LOT 9 Approved Septic System Plan
Howard County Health Department
B20004510
Septic system approved
to serve 7-bedroom
Signature
4/9/2021

WELL NUMBER: HO-17-0321
ADDRESS: 15649 LINDEN GROVE LANE
WOODBINE, MD 21797

PLOT PLAN
LOT 11
LINDEN GROVE
LIBER 1619, FOLIO 341
PLAT NO. 25071
ELECTION DISTRICT No. 4
HOWARD COUNTY, MARYLAND

15649 Linden Grove Lane * Revised Floor Plans

FIRST FLOOR PLAN
 SCALE: 1/4" = 1'-0"

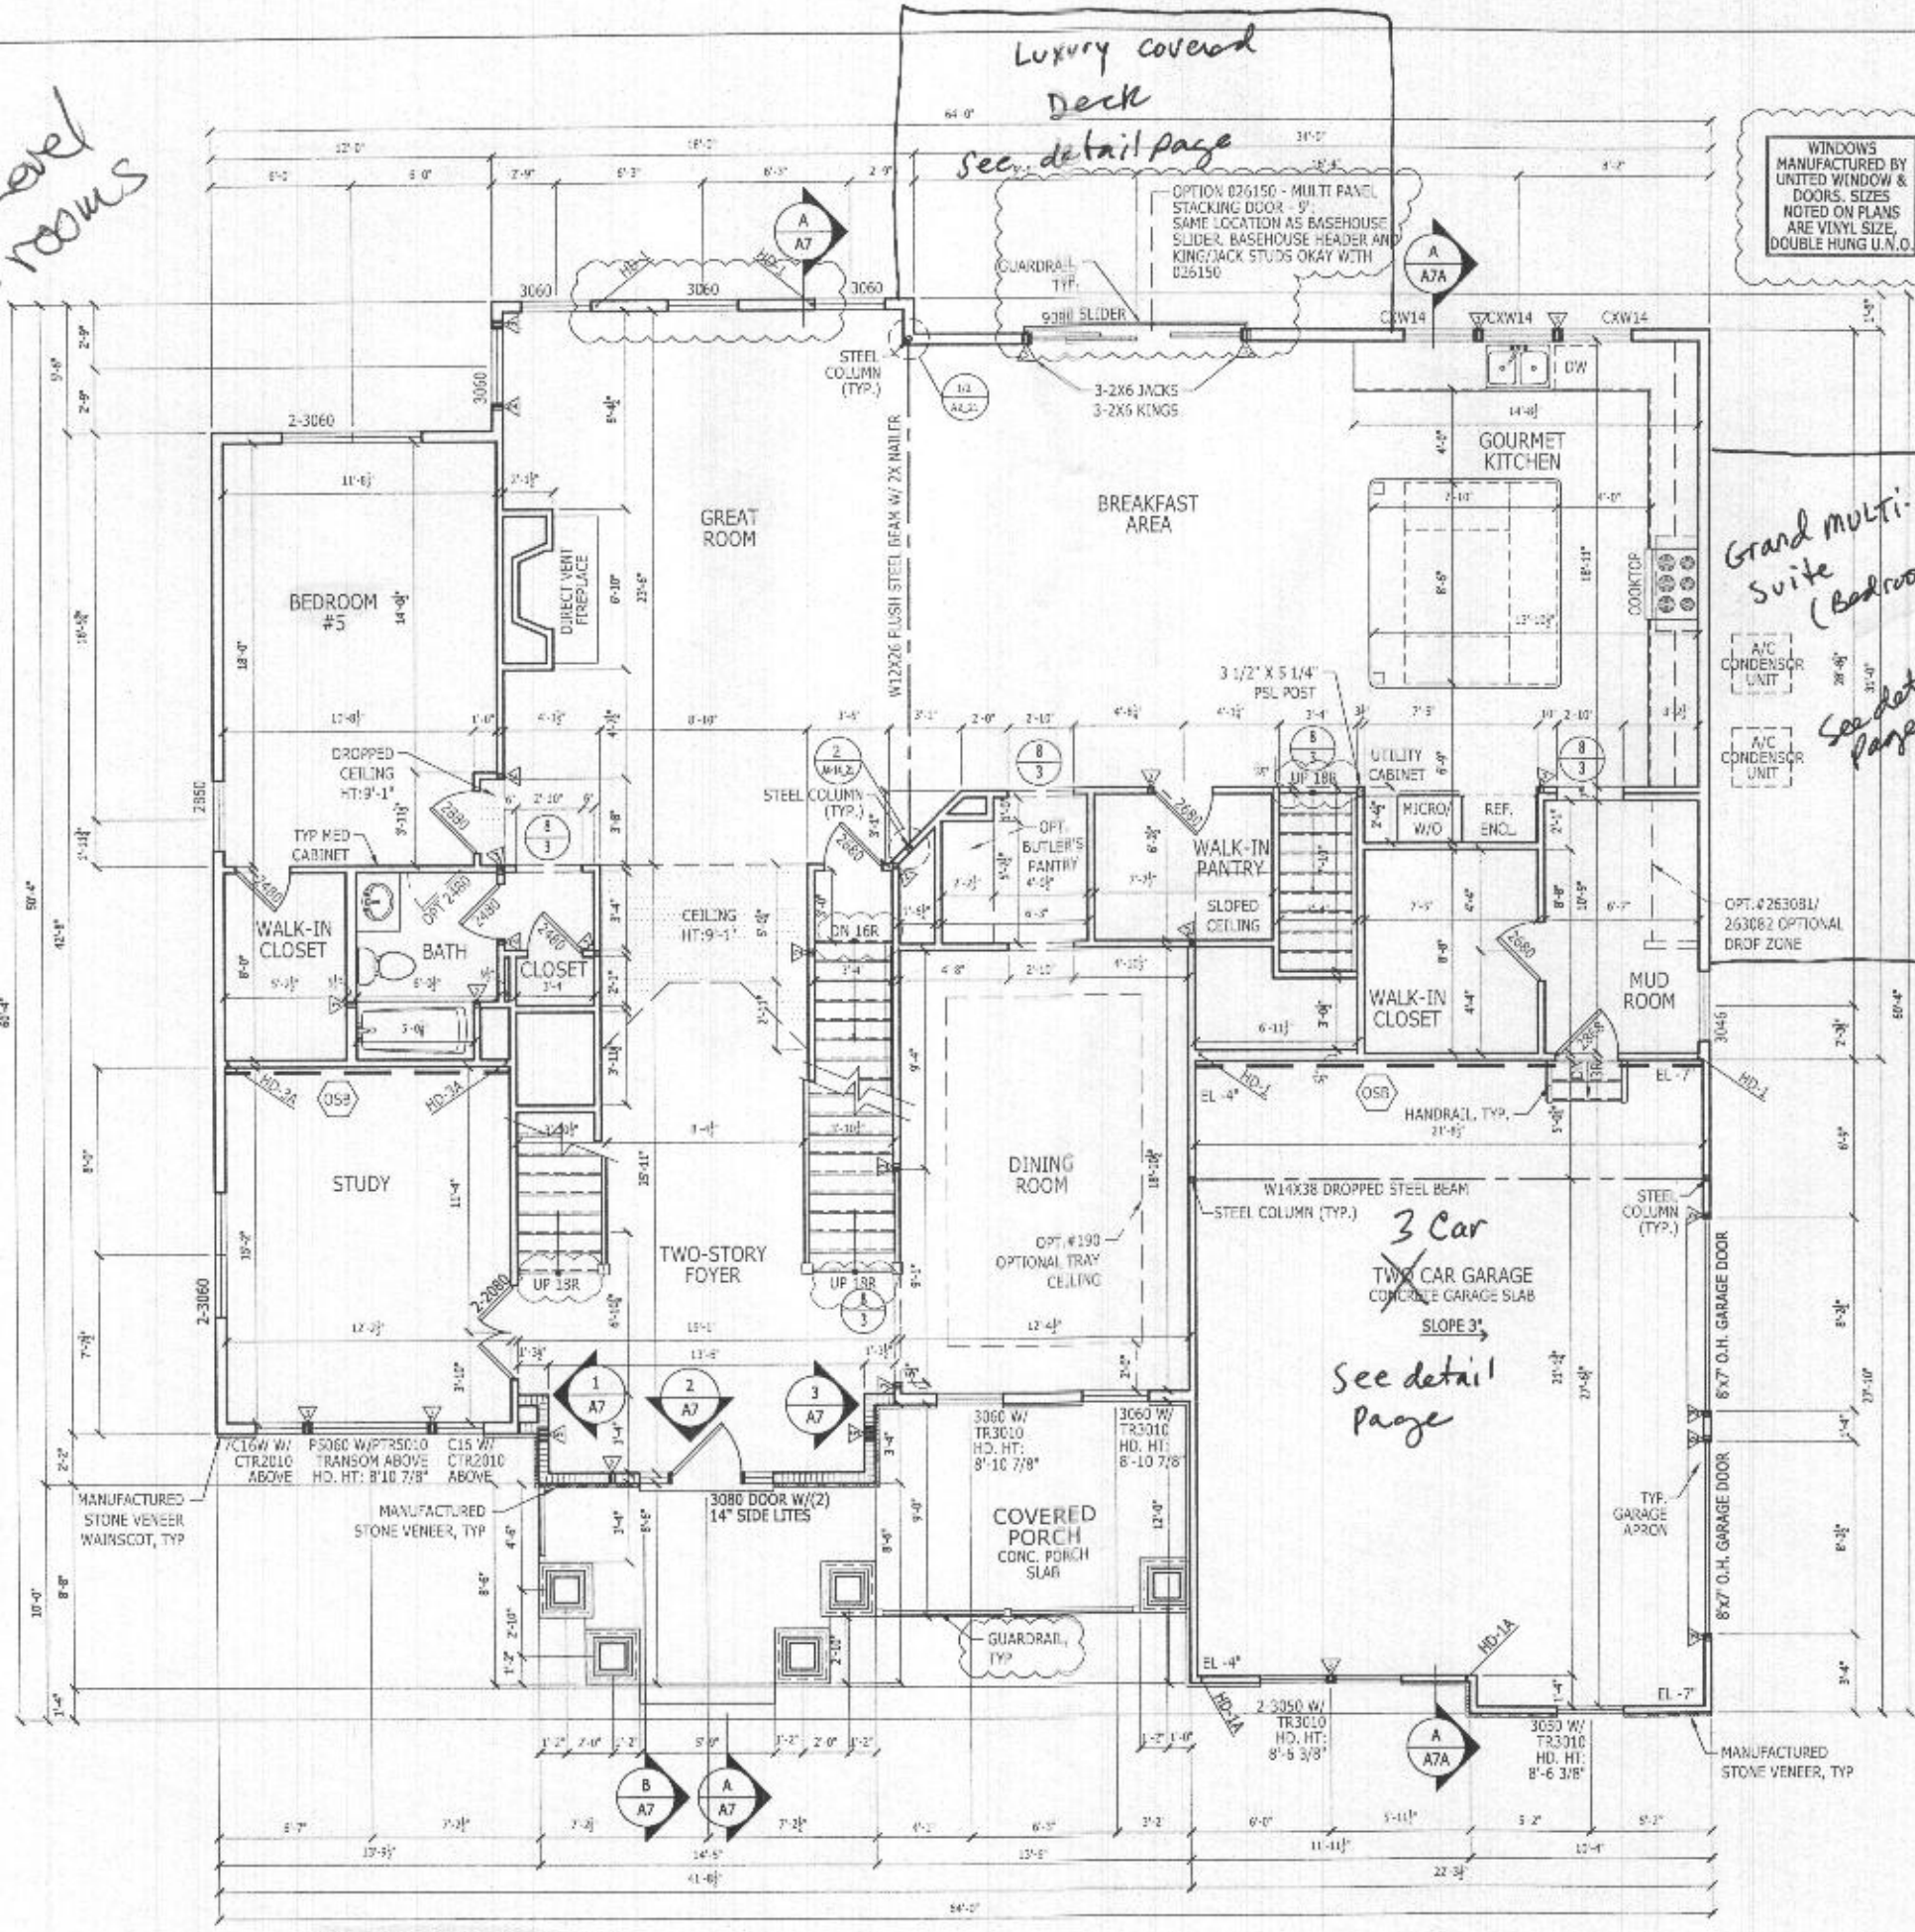
OK RB 4/9/21
Main Level 2 Bed rooms

COUNTRY MANOR *Shown*
See detail page for Lexington ELV

SECOND FLOOR PLAN
 SCALE: 1/4" = 1'-0"

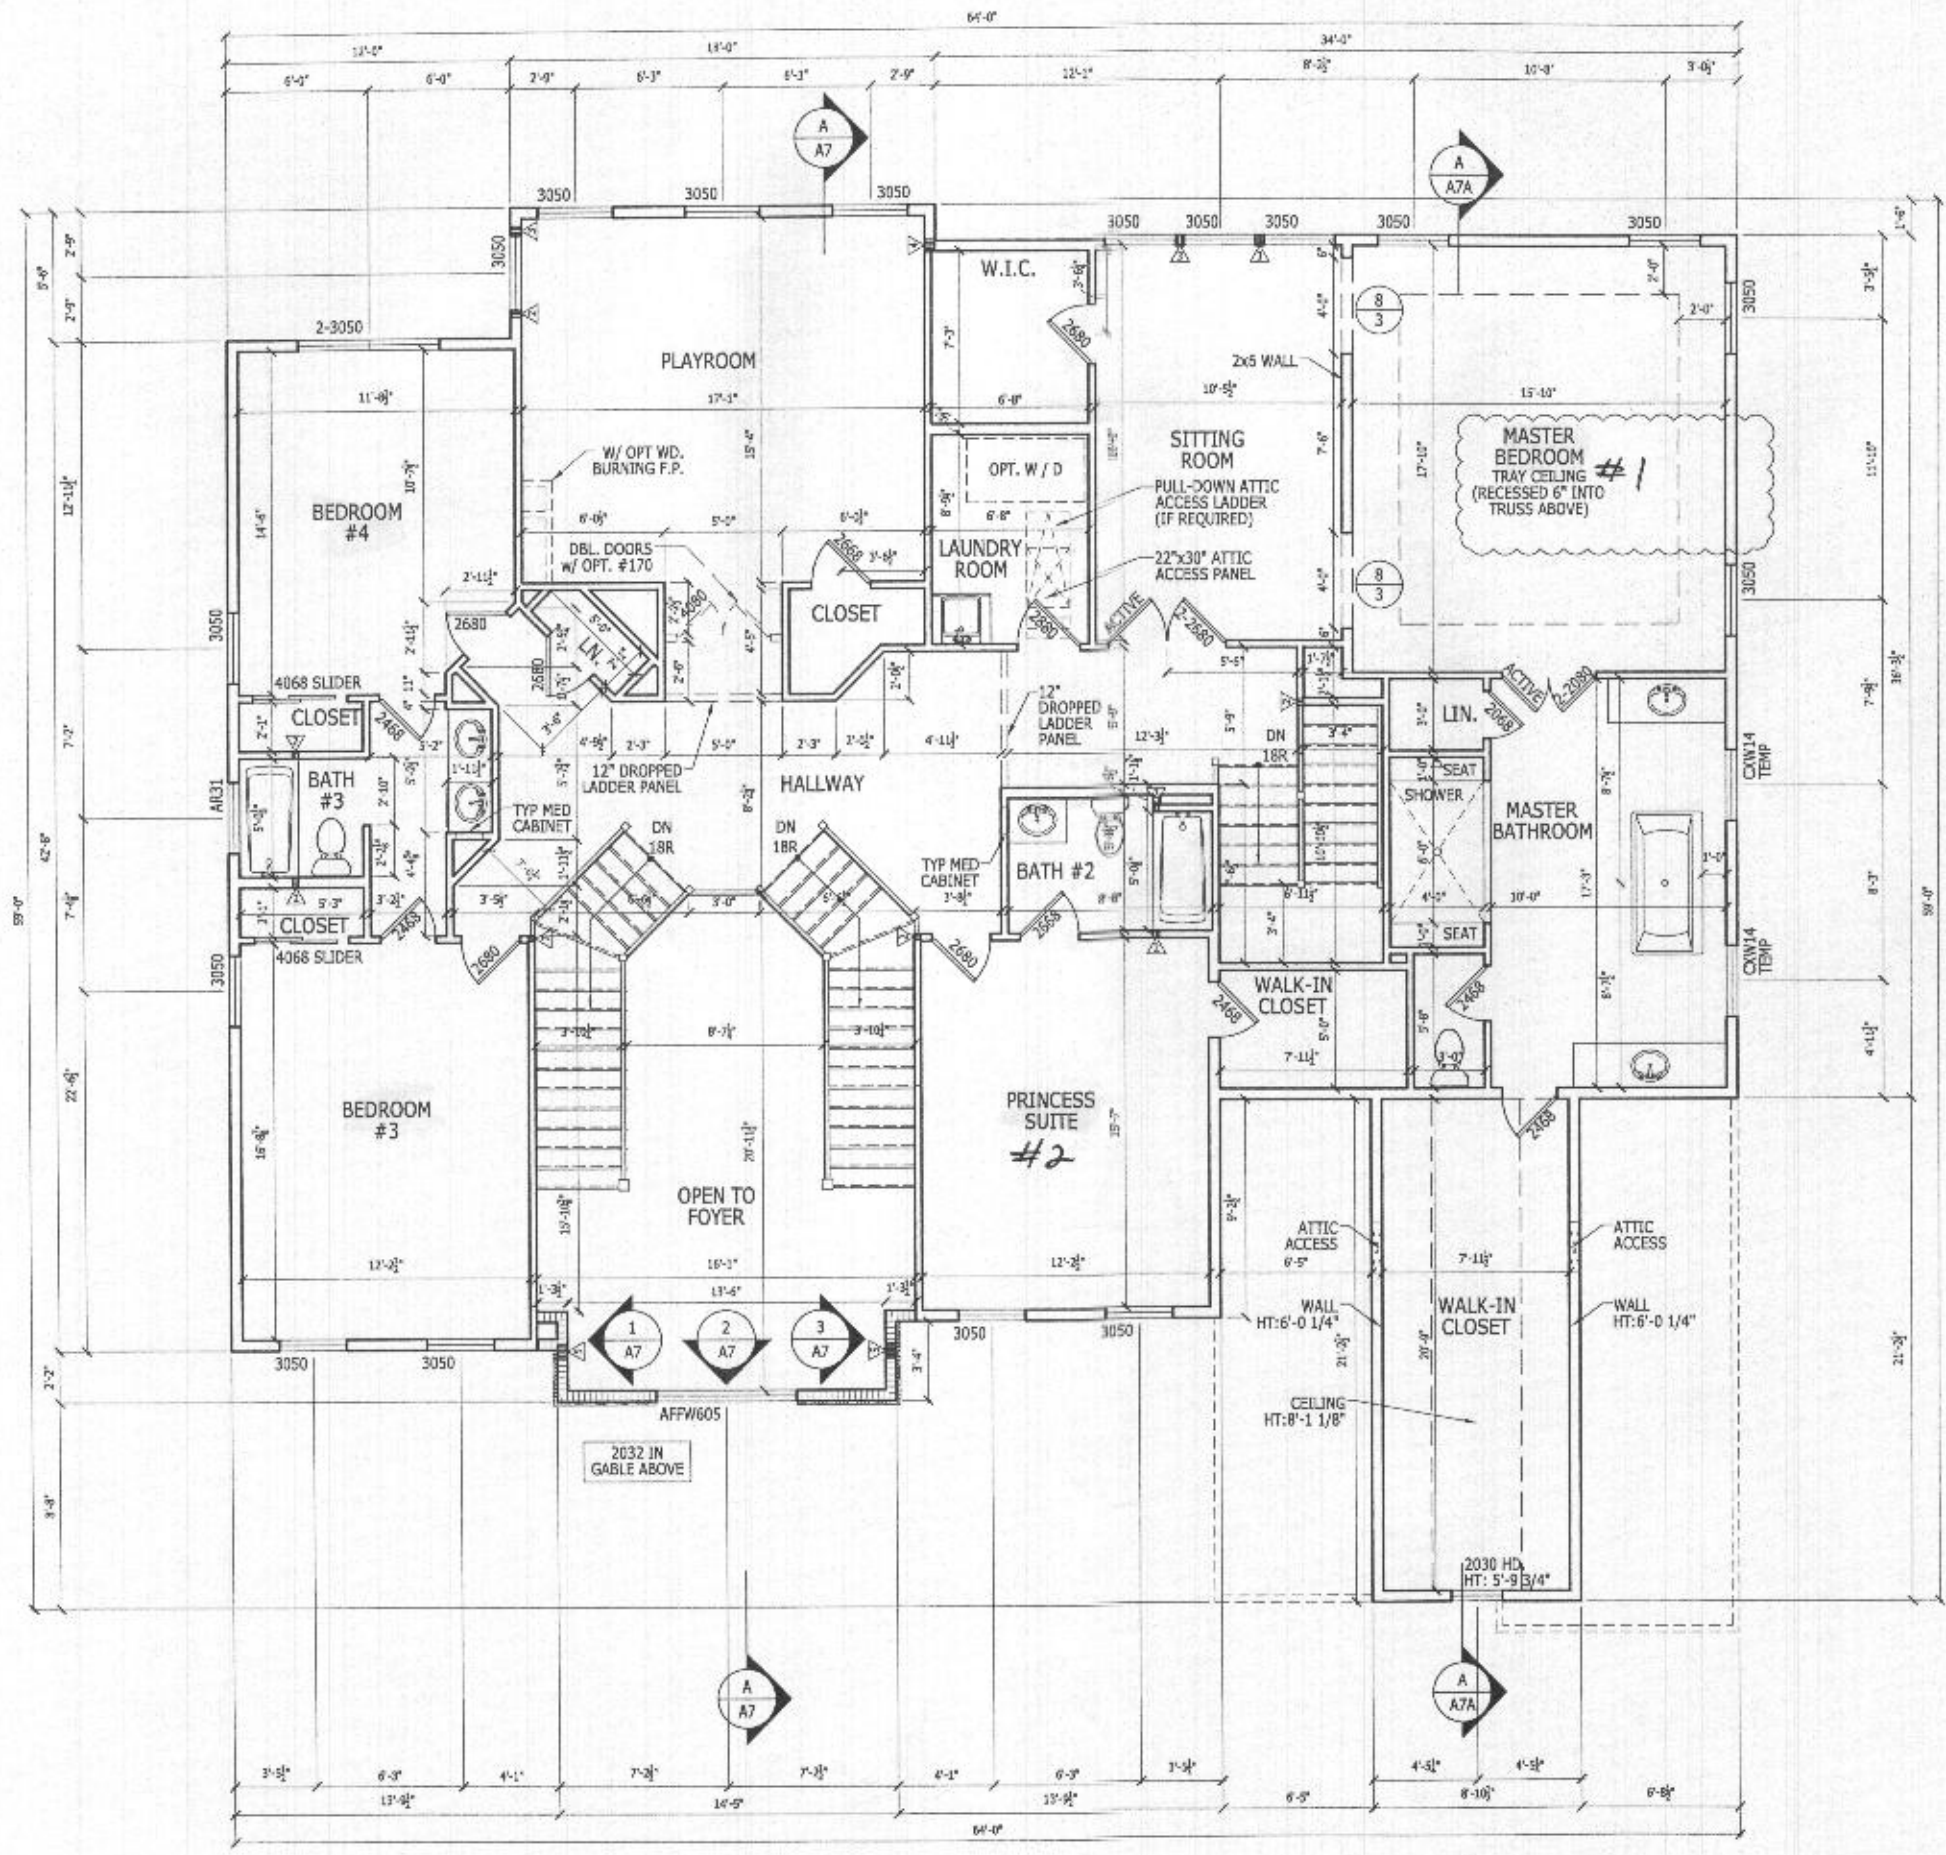
*Upper level
 4-bed rooms
 OK!
 1/12/21*

COUNTRY MANOR *shown*
 See detail page for Lexington etc

SECOND FLOOR PLAN
 SCALE: 1/4" = 1'-0"

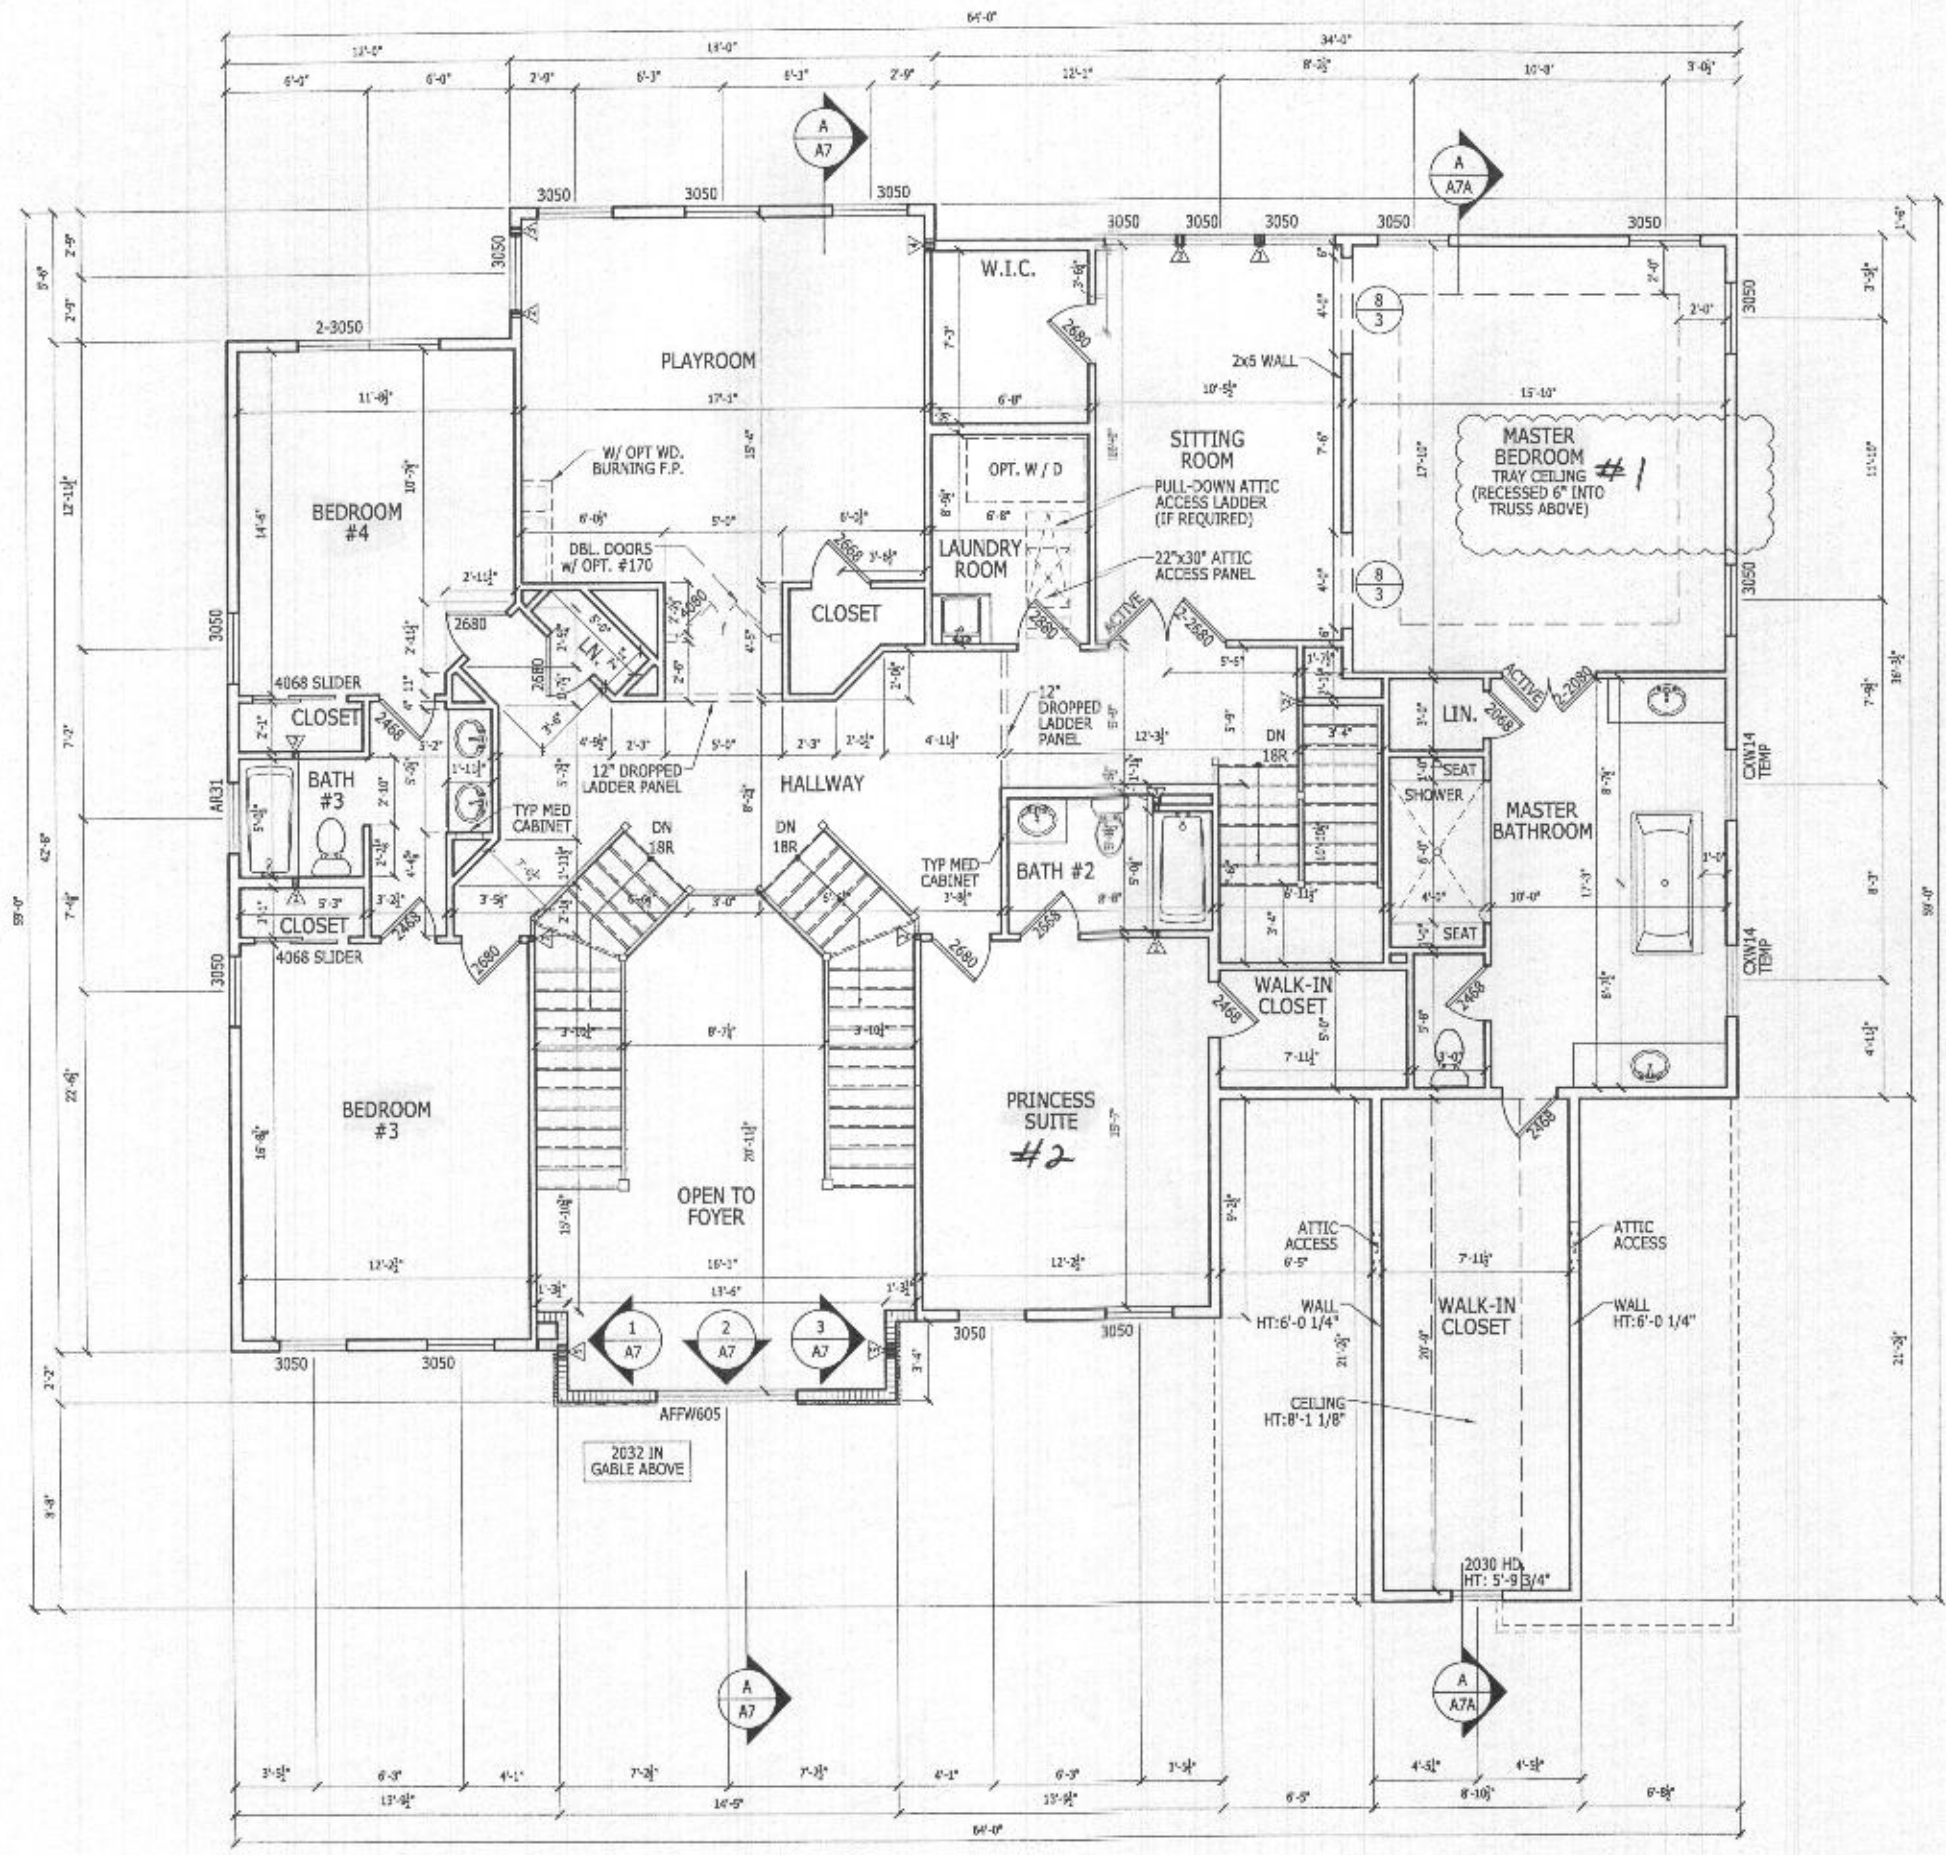
COUNTRY MANOR *shown*
See detail page for Lexington etc

Upper level
4-bed rooms
OK!
rs
4/2/21
